# Examination of NERC GMD Standards and Validation of Ground Models and Geo-Electric Fields

## REPORT TO THE COMMISSION TO ASSESS THE THREAT TO THE UNITED STATES FROM ELECTROMAGNETIC PULSE (EMP) ATTACK

**July 2017**

Figure 16 – Comparison of Metatech east-west geo-electric field calculation and NERC east-west geo-electric field calculation for May 4, 1998 storm event.

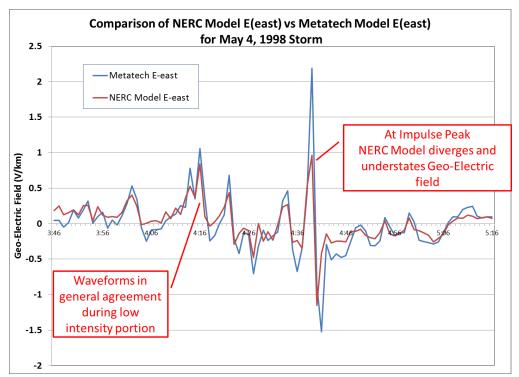
In the earlier portions of the storm simulation, the relative agreement between the two models for the geo-electric field is quite close. This occurs during a quieter and less intense portion of the storm. However as shown at the large impulse around time 4:39 UT, there is a divergence of agreement between the two models with the NERC modeling method understating the Metatech model results by a significant margin. After that impulse is over, the two models again come into relatively close agreement again. This suggests a problem in the NERC model of understating the intensity for more intense impulsive disturbances. As previously shown, the intensity in dB/dt is ~600 nT/min at time 4:39 UT, while it is generally below 100 to 200 nT/min at all other times during the simulation. Hence this higher intensity may be an important inflexion threshold within the NERC model.

Figure 17 – Comparison of Metatech model GIC to NERC model GIC at Chester.

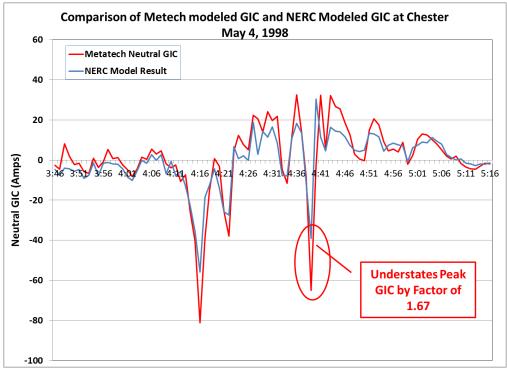
As previously discussed Ohm's Law requires a sufficiently large enough geo-electric field to create the GIC flow observed at this location. Using the NERC model geo-electric fields it is possible to calculate the GIC flow and compare this to the GIC flow calculated for the Metatech model and even to the observed GIC. Figure 17 provides a comparison of the NERC model GIC with that computed in the

Metatech model. Figure 18 compares the same NERC Model GIC result with actual GIC observed at Chester. As both of these figures illustrate, the NERC model results will under predict the GIC at the peak storm intensities. In the case of the peak at time 4:39UT the understatement was similar in both the model comparisons and the observed GIC comparison.

Figure 22 - NERC Model estimated East-West Geo-Electric Field on July 15, 2012 for the NE1 ground model.

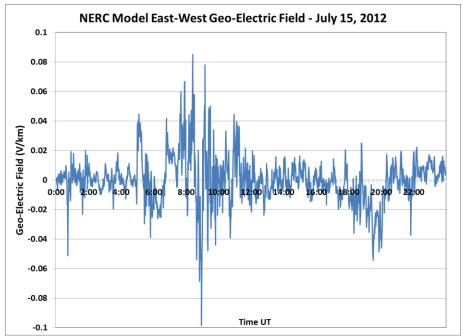
Figure 22 provides a plot of the East-West Geo-Electric Field that would be derived using the NERC model from this storm, using the Ottawa observatory geomagnetic field disturbance conditions as the input. As shown the peak field intensity reaches only ~0.1 V/km which is ~4 times too low to produce the actual GIC observed at Seabrook for this storm event. Hence this storm simulation model provides an example of even worse GIC validation attempt than at Chester. (Not shown is that the peak north-south geo-electric field would have been ~0.12 V/km. But these are also too low and would not couple efficiently with the Seabrook region circuits; therefore this was not a factor in the GIC levels at Seabrook.)

Figure 27 – Comparison of NERC Model geo-electric field with estimated geo-electric field needed to produce Tillamook GIC flows for the Oct 30, 2003 storm

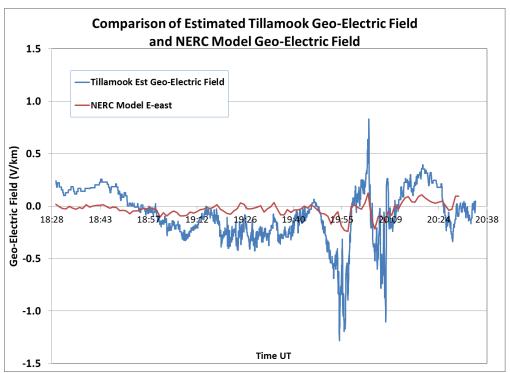
As Figure 27 shows, the peak geo-electric field as strictly constrained by Ohm's law must exceed 1 V/km during portions of the GIC flow where the Tillamook GIC exceeded ~38 amps level. At all times, the NERC model geo-electric field did not exceed even 0.25 V/km. As this comparison illustrates, the NERC model greatly understates the peak geo-electric field intensities at the peak GIC flow portions of the storm. In some cases this understatement is more than a factor of 4 to 5 times too small. This degree of divergence is also worse than what was observed at Chester Maine and is similar to the error level noted for Seabrook.

Figure 30 - Comparison of NERC Model geo-electric field with estimated geo-electric field needed to produce Tillamook GIC flows for the July 15, 2000 storm

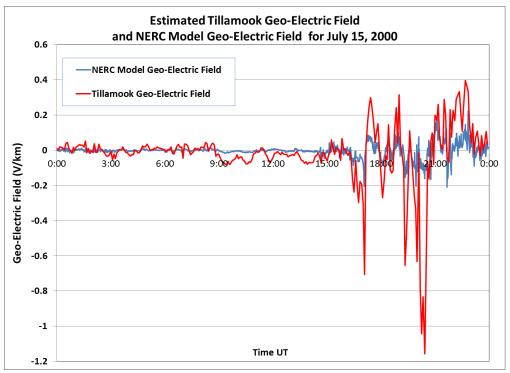
From the GIC observations for this storm, the minimal Geo-Electric field levels necessary to produce the GIC flows observed at Tillamook can be again calculated. This can also again be compared with the estimates used by NERC in modeling this storm event, this comparison is shown in Figure 30. In the comparison of the NERC model geo-electric field with the actual geo-electric field as derived from GIC measurements, the NERC model again greatly under predicts peak V/km intensities, by as much as a factor of ~5 or more at peak intensities times. These results are similar to the results from the Oct 30, 2003 storm as shown in Figure 27 and further confirm that the NERC models will not accurately depict storm conditions.

Figure 31 – Plot Figure 7 from Pulkkinen, et.al.,paper "Calculation of geomagnetically induced currents in the 400 kV power grid in southern Sweden" published 2008 showing storm intensity and GIC comparisons

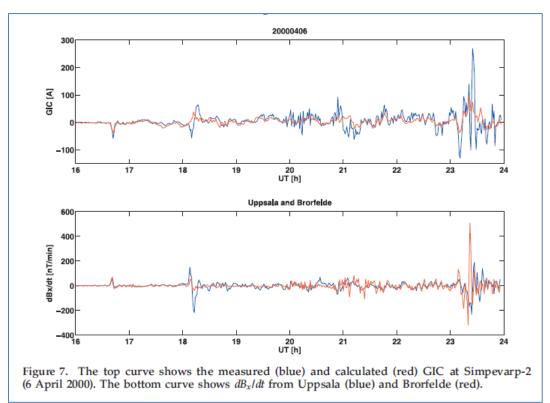
In looking at recent publications by Pulkkinen, et. al., a paper titled "Calculation of geomagnetically induced currents in the 400 kV power grid in southern Sweden" was published in the Space Weather Journal in 2008. In this paper the authors presented results from several storm events that were similar in intensity to the May 4, 1998 storm that was discussed in a prior section of this report. Figure 31 is a set of plots from Figure 7 of their paper showing the disturbance intensity (dB/dt in nT/min) in the bottom plot and the measured and calculated GIC in the top plot. As illustrated in this Figure, the storm intensity is similar to that experienced in Maine during the May 4, 1998 storm at ~500 nT/min. In regards to the comparison of the Measured and Calculated GIC the simulation model greatly under predicts the actual measured GIC during the most intense portion of the storm around hour 23 UT by substantial margins (factor of 3 or more). This is the same symptomatic outcome observed in the NERC model results and provides another independent assessment with possible inherent problems with this modeling approach.

Figure 32 - Plot Figure 4 from Pulkkinen, et.al.,Paper "Calculation of geomagnetically induced currents in the 400 kV power grid in southern Sweden" published 2008 showing GIC comparisons

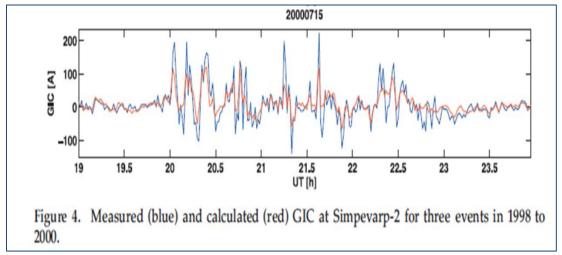
In another example from this same paper, a figure shown below as Figure 32 provides a comparison plot of the Measured and Calculated GIC during the July 15, 2000 storm at the same transformer in southern Sweden. The GIC results as in all prior comparisons greatly diverge during the occurrence of the largest and most sudden impulsive disturbance events, such as those between 21 and 22 UT.
